**SERVICE INFORMATION BULLETIN**

**APPLICABILITY:** 2020-21MY Legacy & Outback

**NUMBER:** 15-295-22

**SUBJECT:** Denso CP1 BASE (Dual 7” Display Screen)  
Unintentional Finger-Touch Operations

**Dual 7” Center Information Display (CID)**

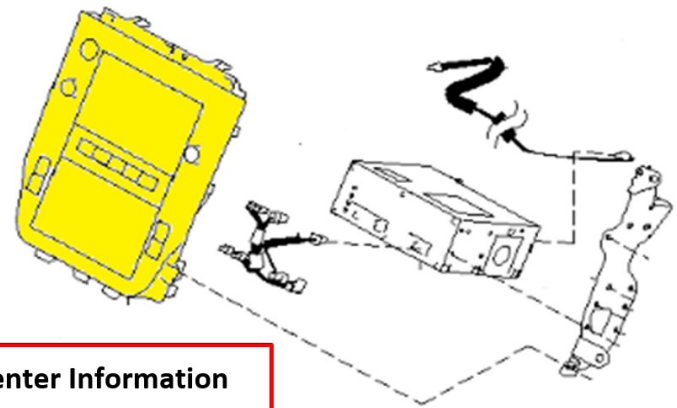
This Service Information Bulletin addresses the rare cases of “ghost touch” (activation of touch screen buttons as though touched by finger(s)). The Dual 7” CP1 BASE Model Center Information Display (CID) touchscreen may appear to detect input without any actual contact (finger or other) with the touchscreen. If this symptom is experienced, the CID will require replacement. Software reprogramming will not remedy this issue. The NEW CIDs contain advanced logic that provides more precise finger detection operation.

Part Description	Part Number
Display Assembly	86213AN60B
	86213AN61B
	86213AN62B
	86213AN63B
